CS Memorandum No. 1429

**Subject:** Configuration Management Board Special Meeting No. 124

**CMB Meeting Minutes #124  
(Special Meeting)**

Contract No. 1252 Tunnels  
PCC No. 1252-13 Cor 79  
 PCC Title Compensation Grouting – Old Navy

Field sketch No. 12  
COR 079

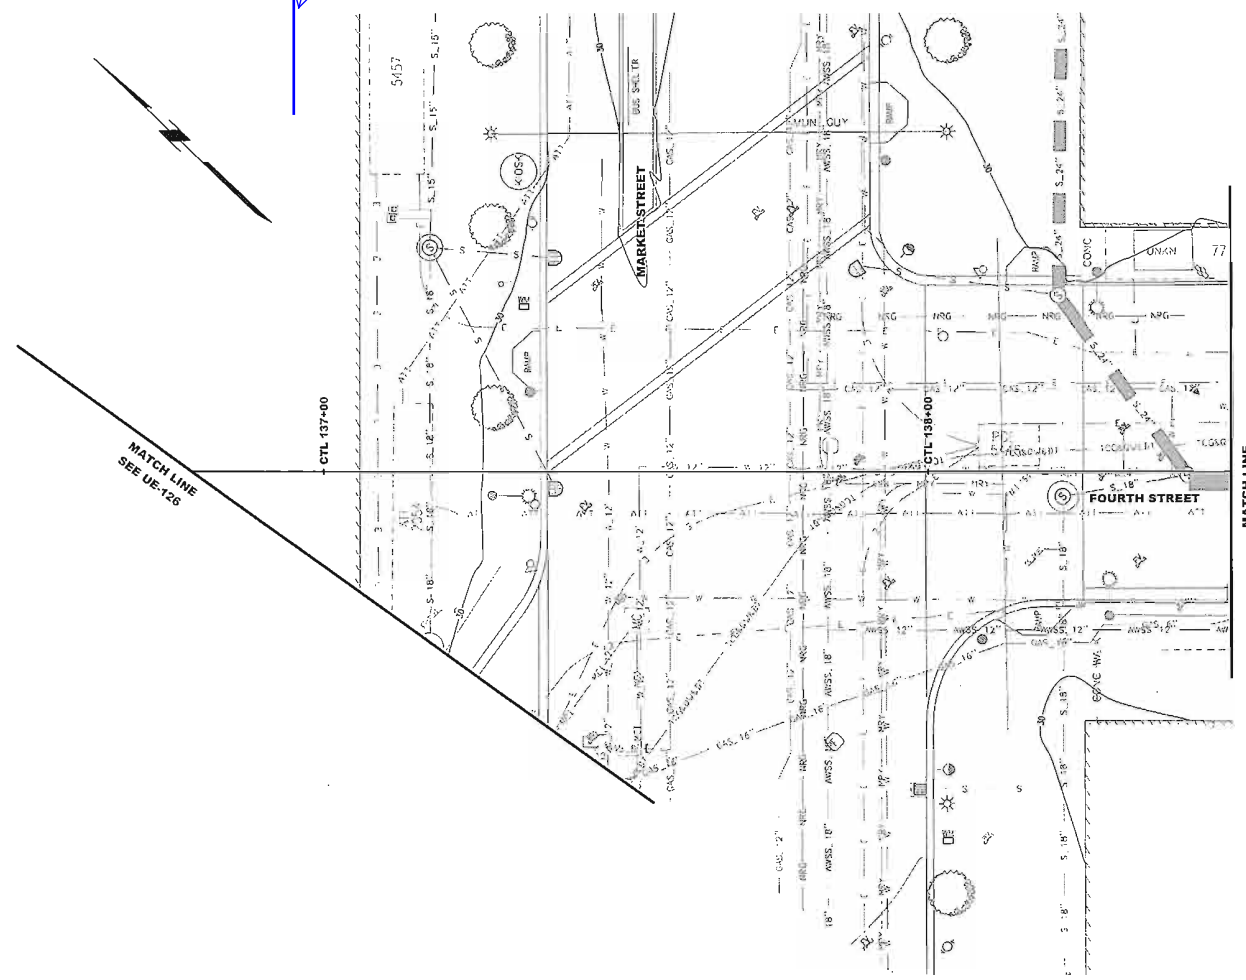
RE/cm to provide notice to PG&E of these Form B costs.

PLACING PG&E ON NOTICE

EXISTING UTILITY COMPOSITE  
CTL 136+80 TO 138+50

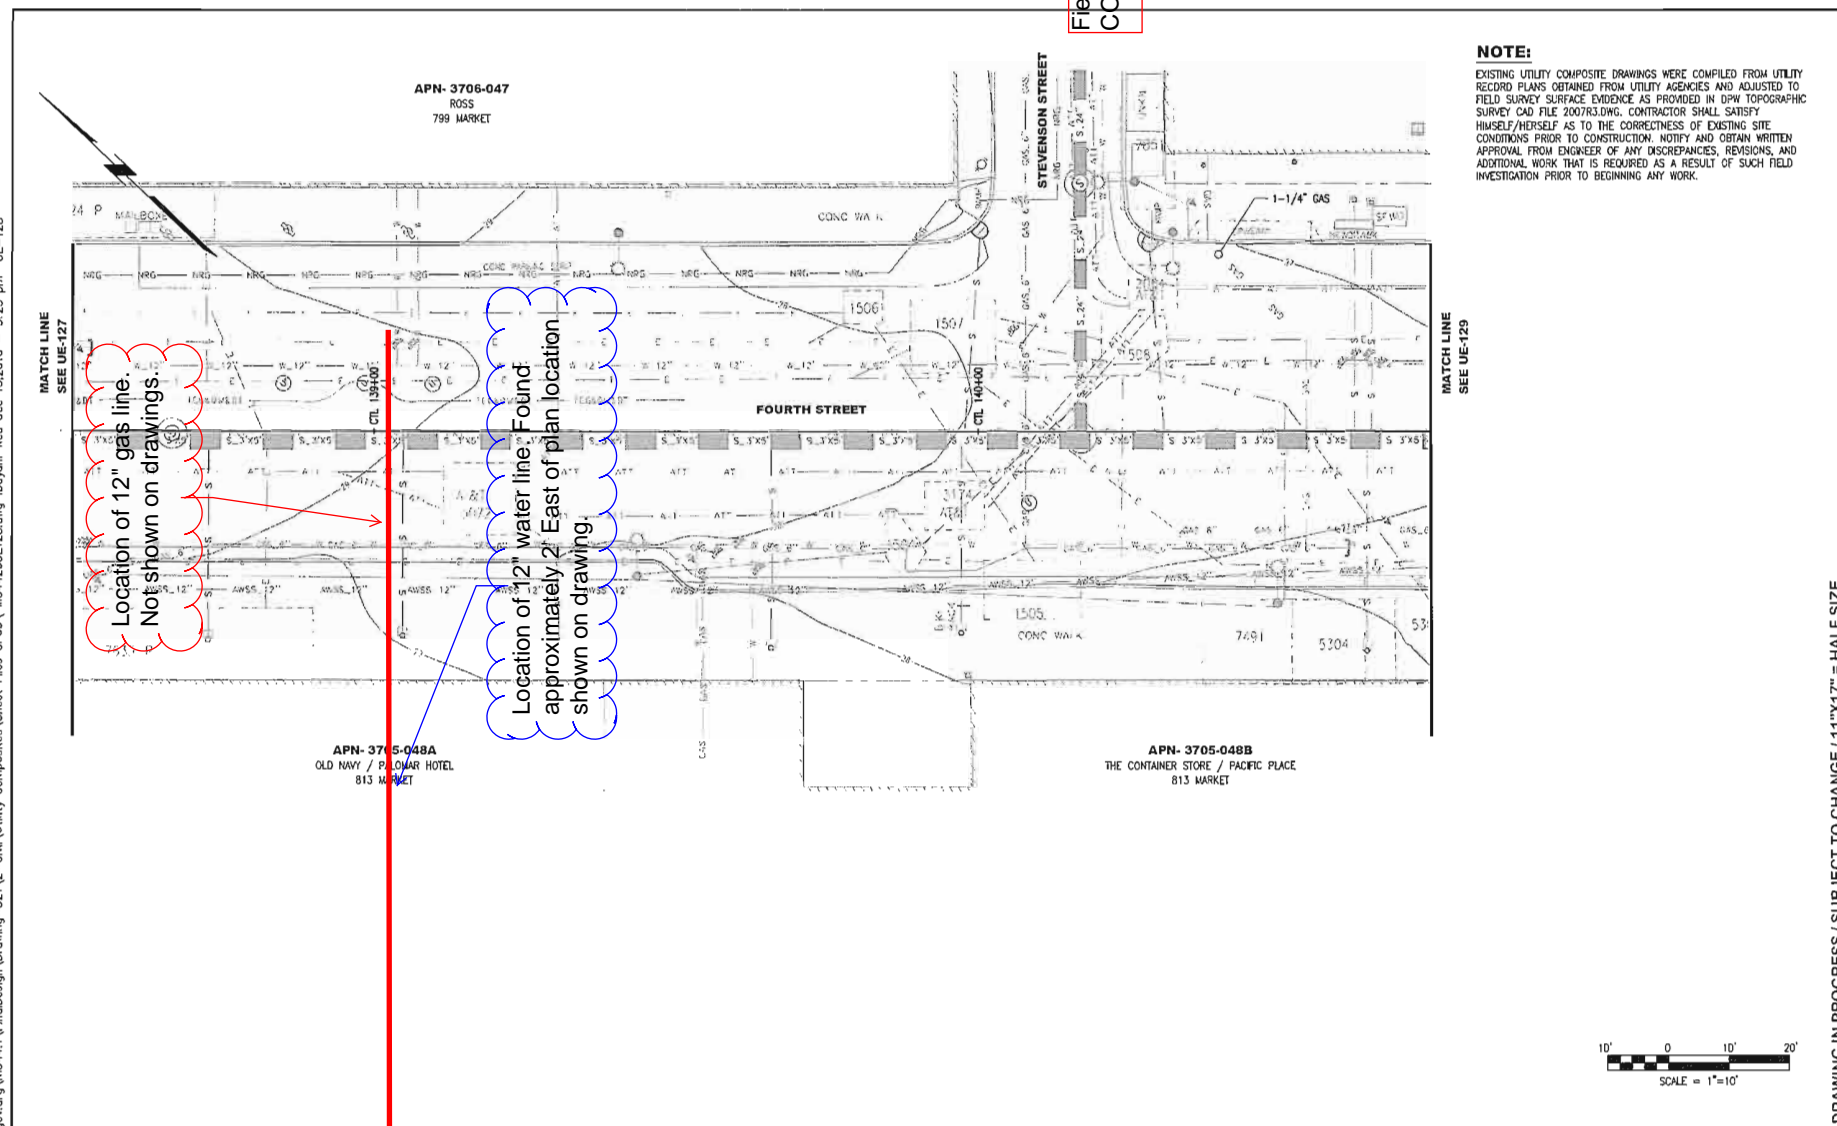
8. CONCLUSION, WHETHER-OR-NOT OBSTRUCTION CAN BE CLASSIFIED AS A DIFFERING SITE CONDITION (BASED ON CONTRACT DOCUMENTS).  
Abandoned ductbanks and steel conduits: The buried obstruction constitutes a differing and unforeseen site conditions as it is not shown in the Contract Drawings. Utility demo drawings do not exist for this location.  
Abandoned gas main: The existing gas main was shown on UE-127 but was omitted in UE-128.

1. There is not sufficient clearance between the existing PG&E lines per the original contract design to drill the compensation grout holes as designed.
2. Numerous unknown buried obstructions were encountered including, but not limited to tile duct banks, concrete of unknown contents, and steel pipes.
3. An abandoned 12" PG&E gas line was found to be approximately 16 feet from face of curb, approximately 4 feet below grade and running the entire length of the trench. The Contract Documents do indicate the presence of a 12" gas line at this location (Contract dwg. BP-124 Rev. 0 & Reference dwg. UE-127). See Field

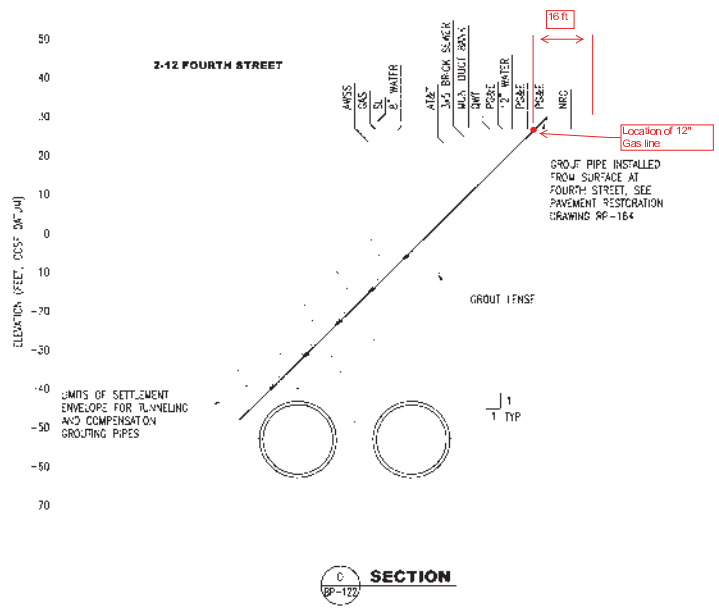
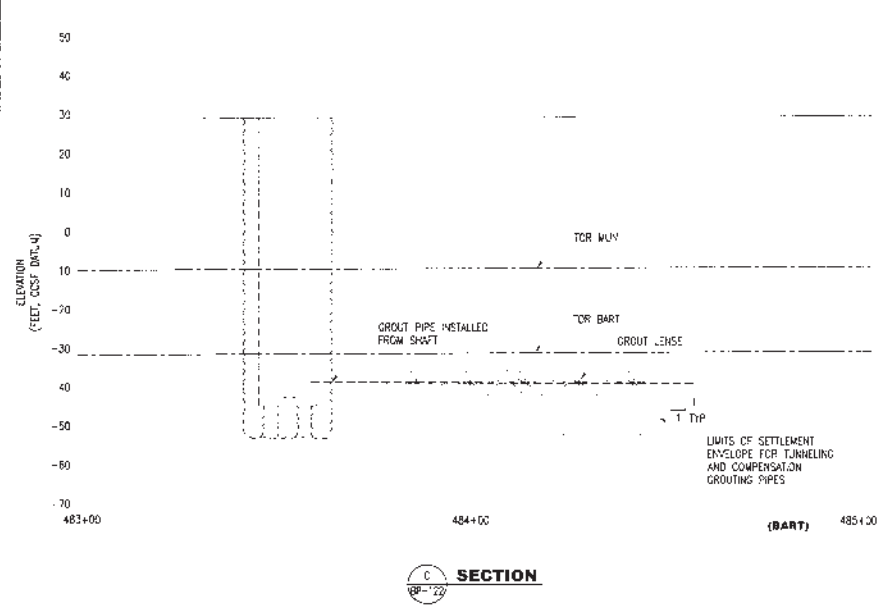
- Sketches 045 through 047. However, the Contract Documents, specifically the Utility Demolition and Utility Composite drawings, do not show whether the 12" gas line is live or needs to be removed.
4. The PGE electrical duct bank was deeper and further east than originally anticipated.
  5. The waterline shown on the drawings was further east than shown on the Contract drawings. See Field Sketches 045 through 046.
  6. A sub-sidewalk basement within the Ross Dress for Less building was discovered to have an unknown roof load capacity. This resulted in the need to bring in a smaller drill rig that could install the compensation grout tubes from the roadway and avoid installation on top of the basement.

1. Perform additional field investigation with a vacuum truck at the original compensation grout hole design proximal points to determine limits of underground obstructions.
2. Remove and dispose of the abandoned PG&E tile duct bank and 12" gas line that runs along the proposed compensation grouting trench alignment.
3. Remove and dispose of PG&E steel pipes within the proposed compensation grouting trench.
4. Demobilize the Klemm drill rig currently being used for installation of the compensation grout tubes.
5. Mobilize a smaller drill rig to be used for installation of the compensation grout tubes.
6. Drill compensation grout holes at the original compensation grout hole design proximal points.
